**06/03/26 Proposal**  
Conditionally Approved

**07/01/26 Proposal**

■ HPC Conditions

CONCEPT RENDERING

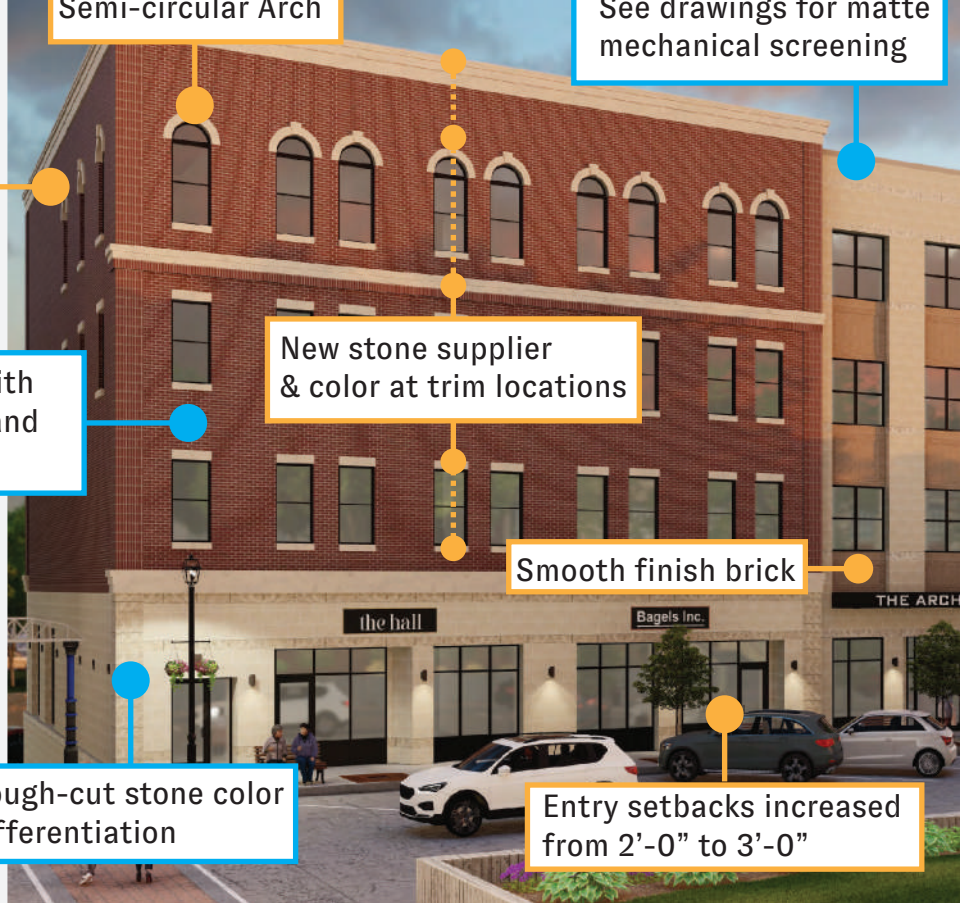
Semi-circular Arch

Additional Refinement
